SPECIAL LETTER 16-13

**SUBJECT:** To ADVISE MOONEY OWNERS/OPERATORS of the **LYCOMING SERVICE INSTRUCTION NO. 1514C (Supersedes Service Instruction No. 1514B) - Issued 10/13/2016 - Roller Tappets Part Information Update (see Attached).**

Service Instruction No. 1514C  
(Supersedes Service Instruction No. 1514B)  
Engineering Aspects are  
FAA Approved

SUBJECT: Roller Tappets Part Information Update

**Figure 1**  
**Roller Tappet Assemblies**

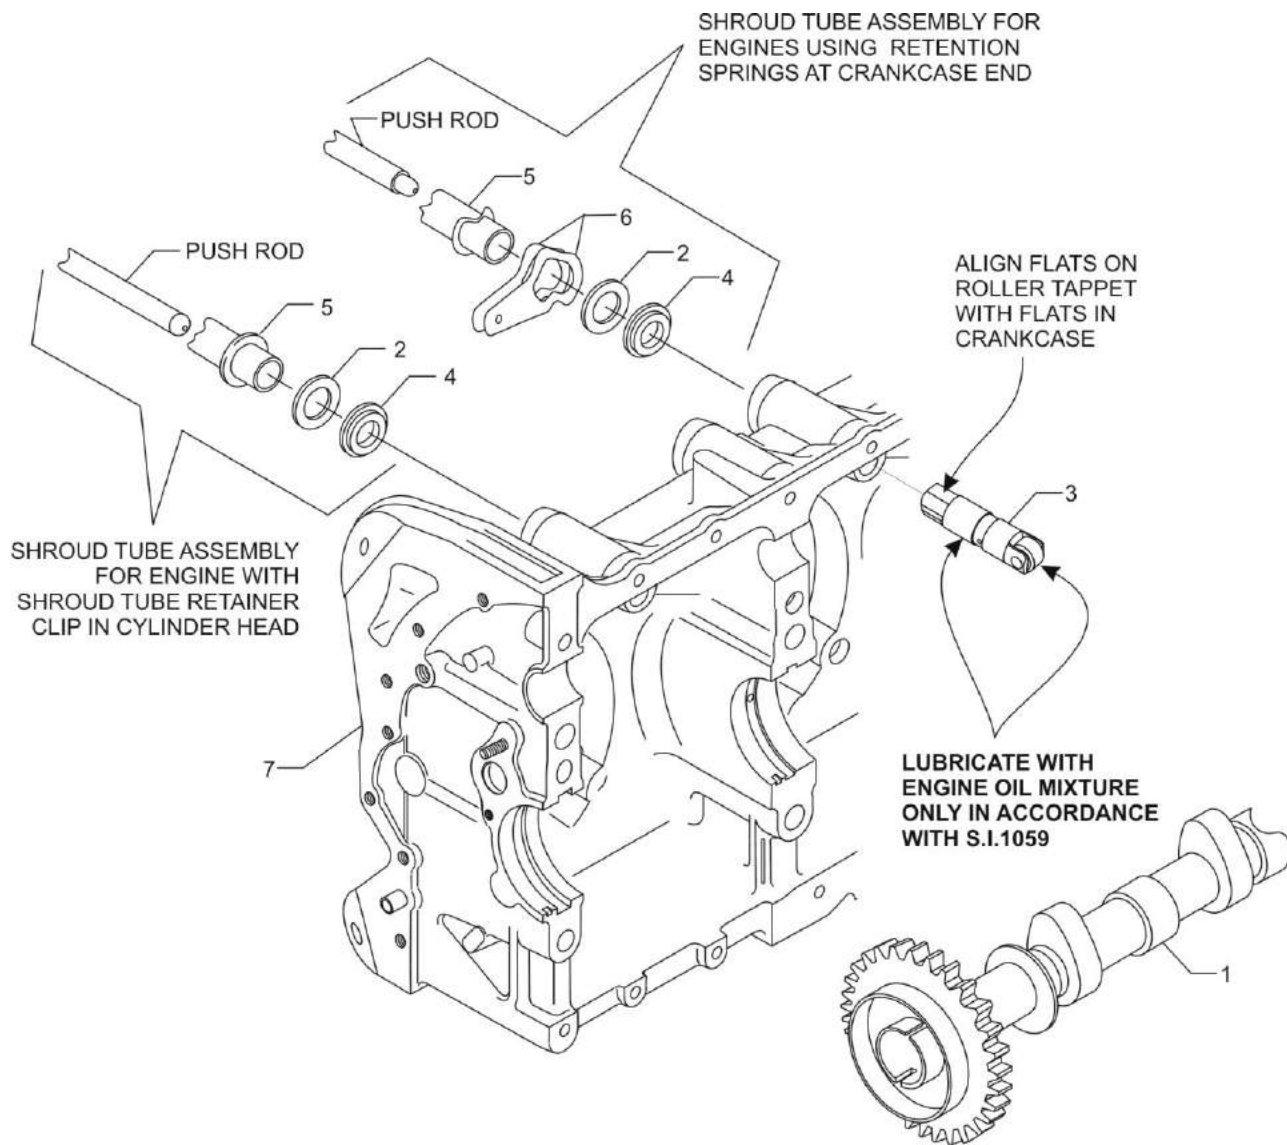
REASON FOR REVISION: Part number updates in Tables 1 and 2

**WARNING:** ROLLER TAPPET PARTS ARE NOT INTERCHANGEABLE WITH CURRENT FLAT FACED TAPPETS.

If it is necessary to remove the roller tappet bodies prior to overhaul, they **must be reinstalled in the same location in the crankcase.** The roller tappets are indexed with flats in the new crankcase. It is possible to assemble the roller tappet bodies in two different orientations 180 degrees apart. Either orientation is acceptable while reinstalling. Lubricate all tappet bores, cam lobes and roller tappets with engine oil mixture only. (Refer to the latest revision of Service Instruction No. 1059.) Install the shroud tube seal in the crankcase, then install the shroud tube.

Following is a list of the parts, roller tappet part numbers and flat tappet part numbers for four-cylinder aircraft engines. (Refer to illustration.)

Following is a list of the parts, roller tappet part numbers and flat tappet part numbers for six-cylinder aircraft engines. (Refer to illustration.)

<b>Item No.</b>	<b>Current Flat Tappet P/N</b>	<b>New Superseding Roller Tappet P/N</b>	<b>Description</b>
1	LW-18840	15M23452	Camshaft Assy.
1	LW-18845	15M23454	Camshaft Assy. (Left-Hand Engine Rotation)
1	LW-18843	15M23456	Camshaft Assy.
1	15M19407	15M23496	Camshaft Assy. (Left-Hand Engine Rotation)
2	66728	01L23459	Washer, .78 ID x 1-3/8 OD x .041
3	72877	LRT23381	Body Assy., Hydraulic Tappet Roller
4	LW-18661	06A23493	Seal, Shroud Tube
5	LW-11485	15G23461	Shroud Tube
5	72255	15G23462	Shroud Tube
5	68987	15G23494	Shroud Tube
6	LW-13077	15H21201	Spring, Shroud Tube
7	LW-13823-1	LW-13823-5	Crankcase Assy.
7	LW-18399-1	LW-18399-5	Crankcase Assy.
7	LW-18402-2	LW-18402-5	Crankcase Assy.
7	LW-18770-1	LW-18770-5	Crankcase Assy.
7	11B19524-1	11B19524-5	Crankcase Assy.
7	11B20061-1SL	11B20161-1SL	Crankcase Assy.
7	11B20061-1SH	11B20161-1SH	Crankcase Assy.
7	11B20061-1SB	11B20161-1SB	Crankcase Assy.
7	11B20061-1DL	11B20161-1DL	Crankcase Assy.

<b>Item No.</b>	<b>Current Flat Tappet P/N</b>	<b>New Superseding Roller Tappet P/N</b>	<b>Description</b>
1	LW-19340	15N23374	Camshaft Assy.
1	-----	15N26092	Camshaft - No Tach Shaft (Roller Lifter)
2	66728	01L23459	Washer, .78 ID x 1-3/8 OD x .041
3	72877	LRT23381	Body Assy., Hydraulic Tappet Roller
4	LW-18661	06A23493	Seal, Shroud Tube
5	LW-11485	15G23461	Shroud Tube
5	LW-18944	15G23487	Shroud Tube
5	72255	15G23462	Shroud Tube
5	72257	15G23948	Shroud Tube
6	LW-13077	15H21201	Spring, Shroud Tube
7	11E24000-D1	11E24100-D1	Crankcase Assy.
7	11E24000-D2	11E24100-D2	Crankcase Assy.
7	11E24000-S1	11E24100-S1	Crankcase Assy.
7	11E24000-S3	11E24100-S3	Crankcase Assy.
7	11E24000-S4	11E24100-S4	Crankcase Assy.
7	11E24001-S1	11E24101-S1	Crankcase Assy.
7	11E24001-S4	11E24101-S4	Crankcase Assy.
7	11E24002-D3	11E24102-D3	Crankcase Assy.
7	11E24005-S1	11E24105-S1	Crankcase Assy.
7	-----	11E24106-S1 ▲	Crankcase Assy.
7	11F24020-D1	11F24120-D1	Crankcase Assy.
